## PCI-SIG ENGINEERING CHANGE NOTICE

<b>TITLE:</b>	Tx Blanking and SYSCLK on Socket 1 Related Pinouts
<b>DATE:</b>	October 19, 2014
<b>AFFECTED DOCUMENT:</b>	M.2 Spec Rev 1.0
<b>SPONSOR:</b>	Ra'anana Sover; Intel Corp.

Figure 87. Type 2226 SDIO Based Module-Side Pin-Out

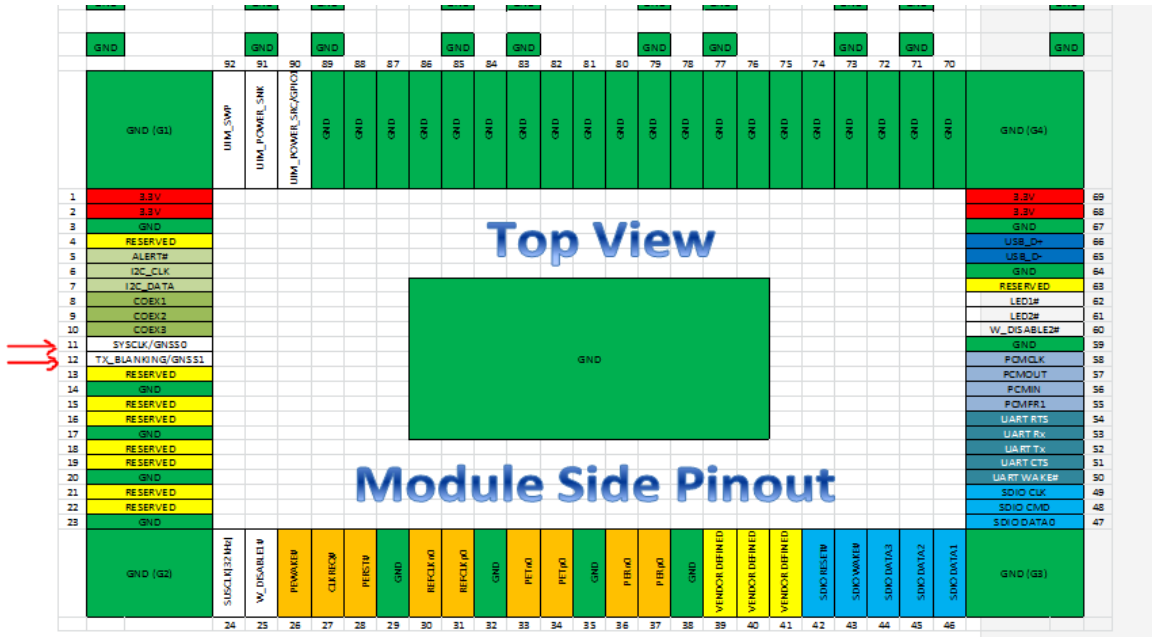
The proposed change is to include 2 GNSS Aiding signals, that we already have allocated in the Type 1216 pinout, to the Socket 1 Key E pinout and Type 2226/3026 pinout. Due to lack of free pins in the Key E pinout, it is proposed to define 2 SDIO Input signals as dual functional pins. They would be defined with their original SDIO functionality along with and alternate GNSS Aiding signals functionality to enable a GNSS solution on Type 2230 solutions on Socket 1 Key E solutions. The GNSS signals to be added are the Tx Blanking and SYSCLK signals and it is suggested to overlay them on the SDIO RESET# and SDIO CLK respectively which are also inputs. In this way it is less likely to cause a potential contention.

In the Type 2226/3026 pinout, there is no need for selection as these TX\_BLANKING and SYSCLK signals would be replace RESERVED pins similarly to the way and location these signals were added to the Type 1216 pinout in the past.

Update the Type 2226 pinout diagram in Figure 87 as follows:

Figure 89. Type 3026 Display Port Pinout Extension Over an SDIO Based Module-Side Pin-Out

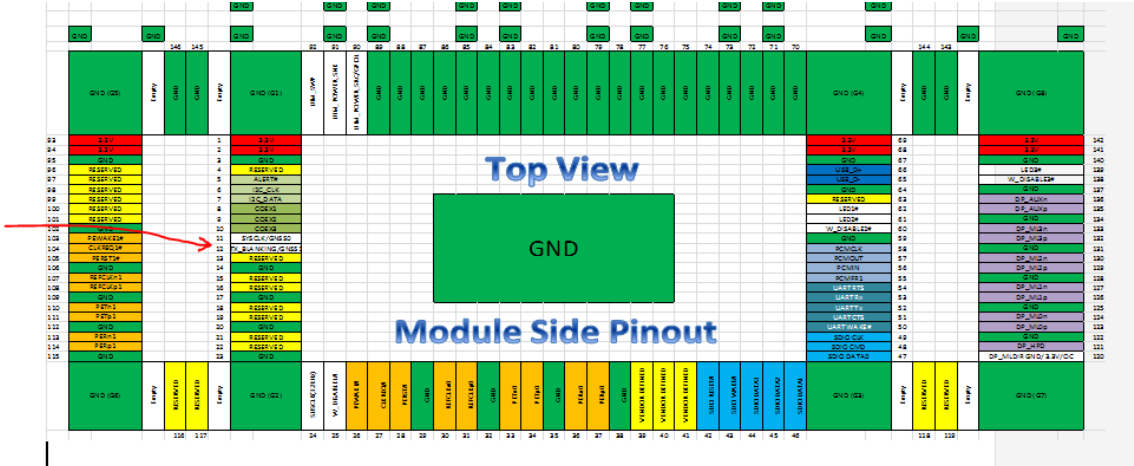
Update the Type 3026 pinout diagram in Figure 89 as follows:

Changes to pins 11 & 12

**Figure 91. Example Connection of the GNSS Signals in a Platform Using M.2 Modules**

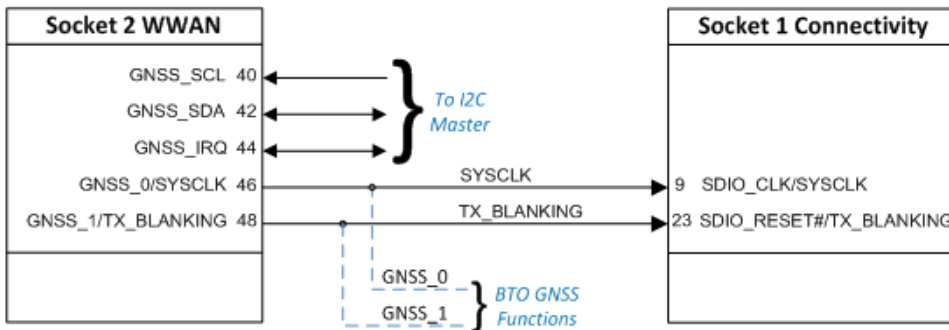
Add a complementary diagram showing an example of the connections of the GNSS signals in a platform system as shown above.

All subsequent figure numbers would need to be updated till the end of the document.
